October 15, 2014

Subject: The Residences of South Brookline – Comprehensive Permit Application
Response to Abutter’s Stormwater Management and Traffic Concerns

POROUS ASPHALT PAVEMENT SECTION (STA.2+00)

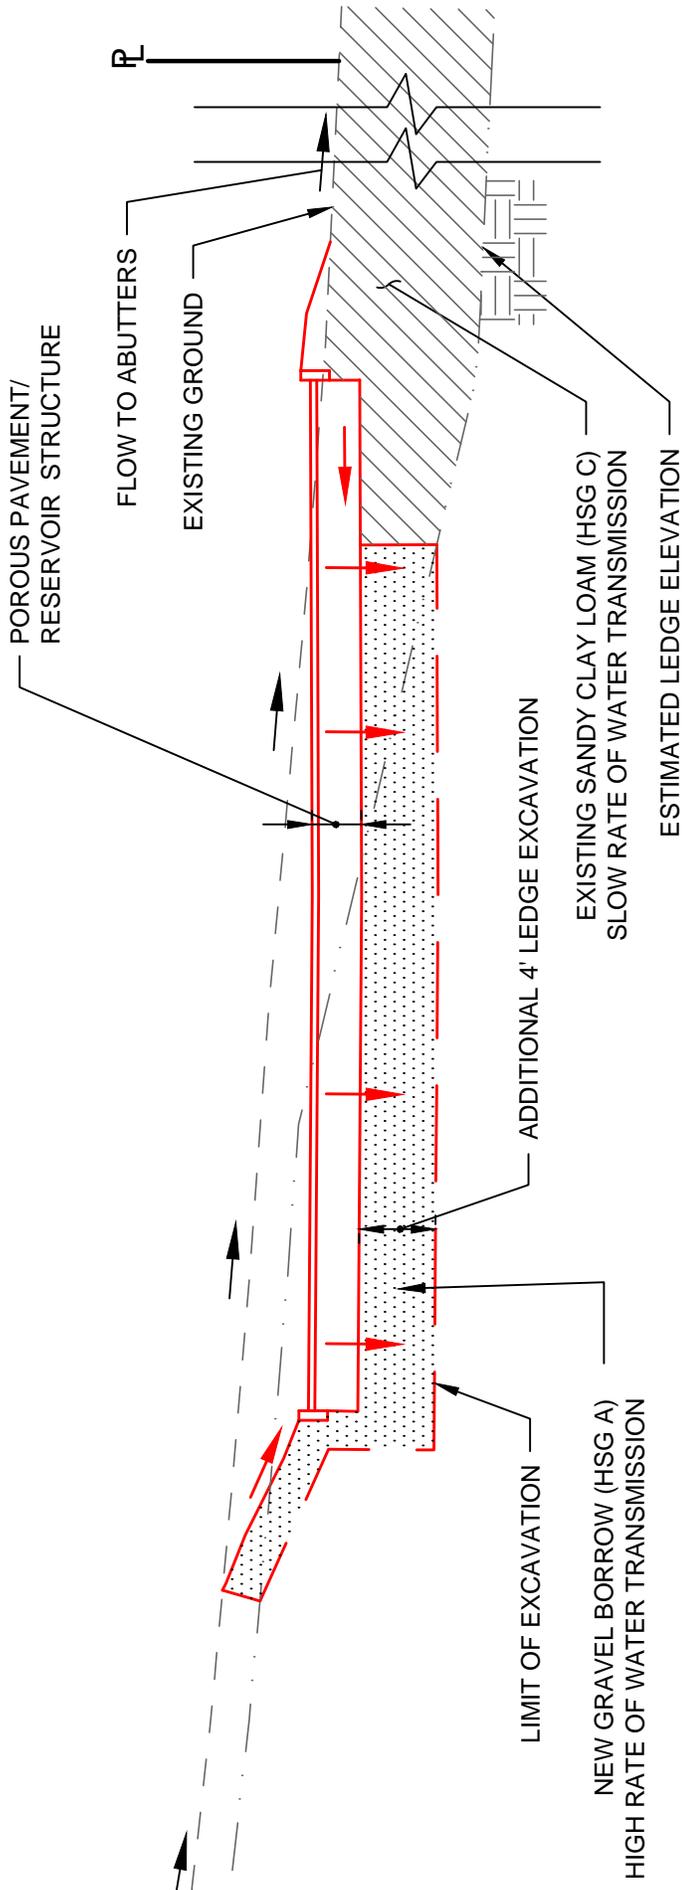
The attached cross section indicates how the installation of the porous pavement parking area may reduce the amount of stormwater runoff to the abutting properties along Ashville Road. Currently the existing site is predominately a wooded/grass surface with poorly draining soils that is underlain by ledge at various depths. As was stated at the meeting, a little rain causes water flow down the site to pond in yards and basements fairly quickly, indicating that very little water is currently getting into the soil. The site area for proposed porous pavement section will be excavated to remove ledge, filled with gravel and the porous pavement section cutting off the overland flow to residences. Water will enter the pavement section and flow through the least resistant (most porous gravel) soils and not through the existing poorly draining soils between the porous pavement and abutting properties. It will flow down to the underdrain and be directed to the closed drainage system – no longer flowing to abutting properties.

Conclusion: The project will not solve all existing flooding issues however abutting properties will not be adversely impacted by stormwater runoff from this project.
